DEVIATION REQUEST AND DECISION FORM

Project Name : Solace Apartments
Schedule No.(s) : 5407200052
Legal Description : THAT PORTION OF SECTION 7, TOWNSHIP 14 SOUTH, RANGE 65 WEST OF THE 6TH P.M., EL PASO COUNTY, COLORADO, DESCRIBED IN BOOK 5046 AT PAGE 748; AND POWERS AND GALLEY PLAZA FILING NO. 1 AS RECORDED IN PLAT BOOK 1-4 AT PAGE 30 OF THE RECORDS OF SAID COUNTY.

A deviation from the standards of or in Section **2.3.7.E for Turn Lane Design** of the Engineering Criteria Manual (ECM) is requested.

LEFT TURN LANE DEVIATION
 SOLACE APARTMENTS
 JOB NO. 25174.00
 7/14/20
 SHEET 1 OF 1

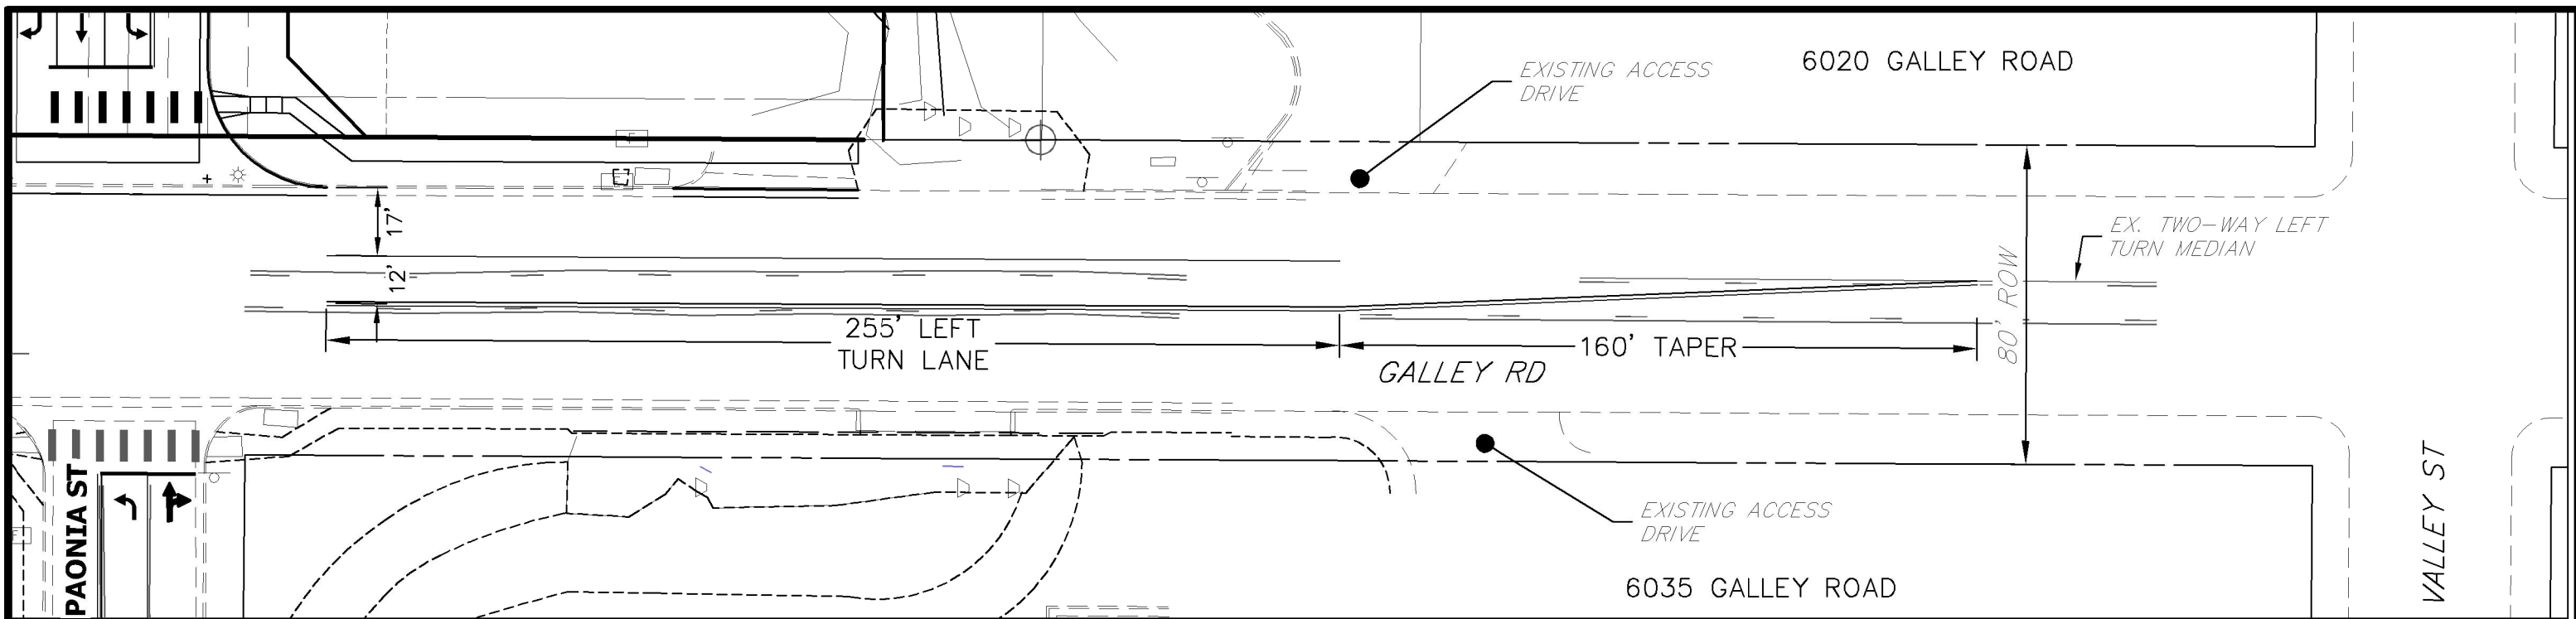
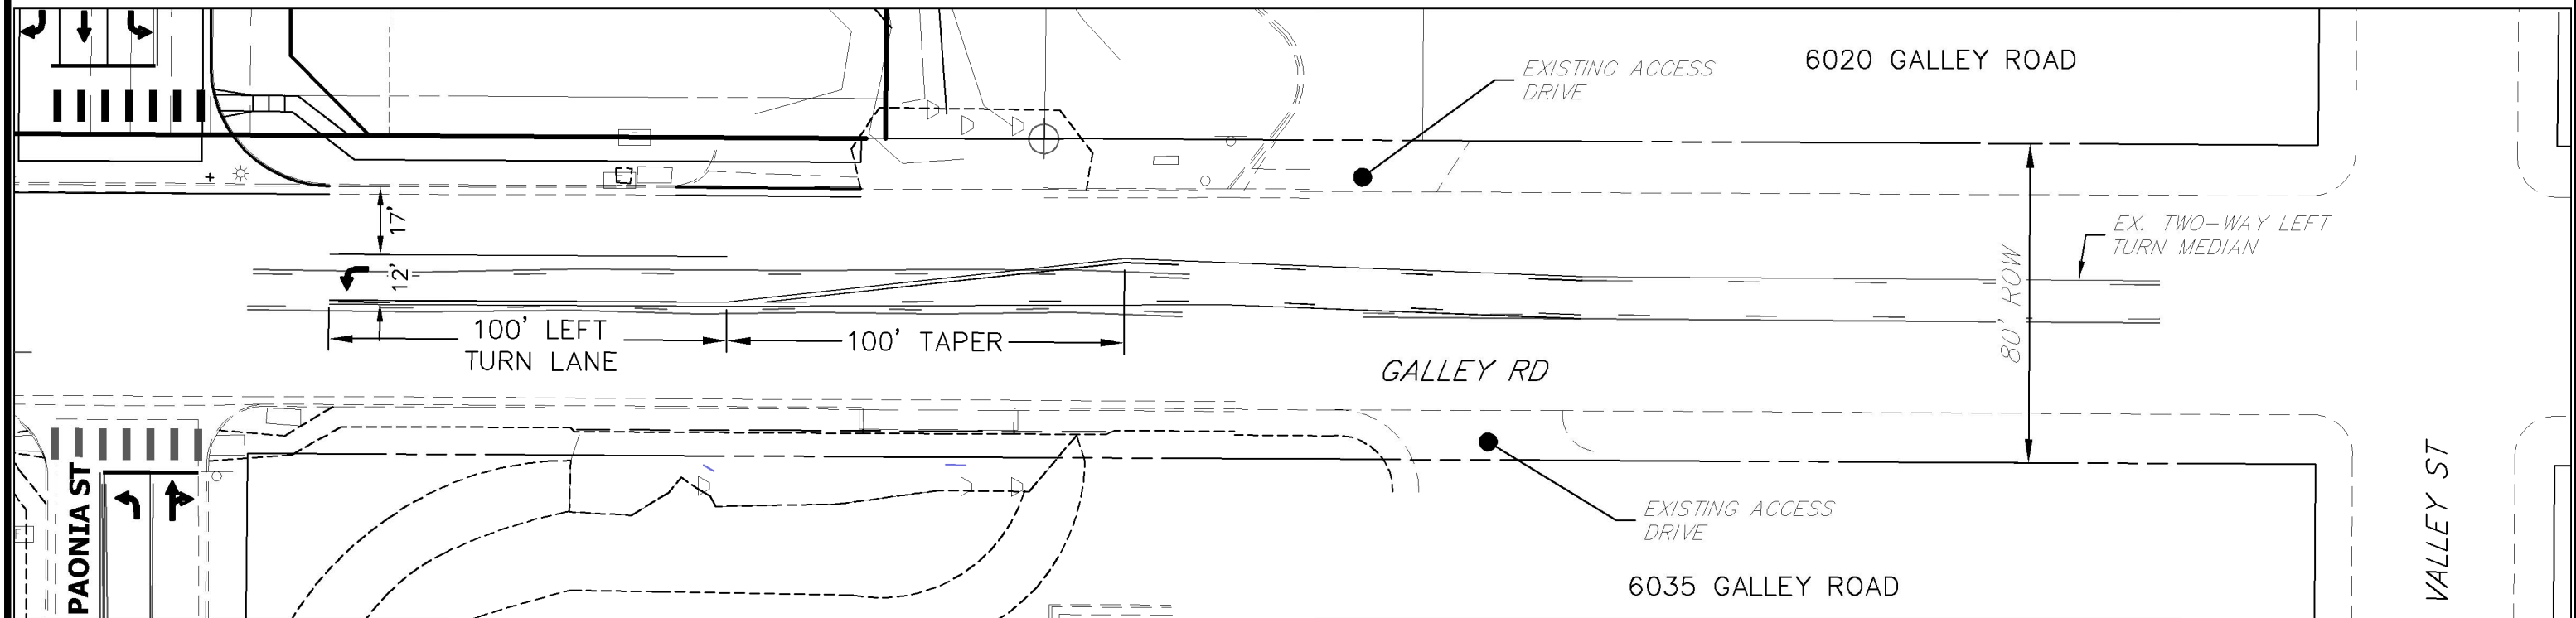
The proposed alternative is for the westbound left turn lane located on Galley Road at the intersection of Paonia Street to have a 100' left turn lane and a 100' taper for a total length of 200'. Typical turn lanes, per Chapter 2, Section 2.3.7.E of the ECM for a 40 MPH design speed, require a total length of 415'. Thus, the proposed alternative is 215' shorter than the standard.
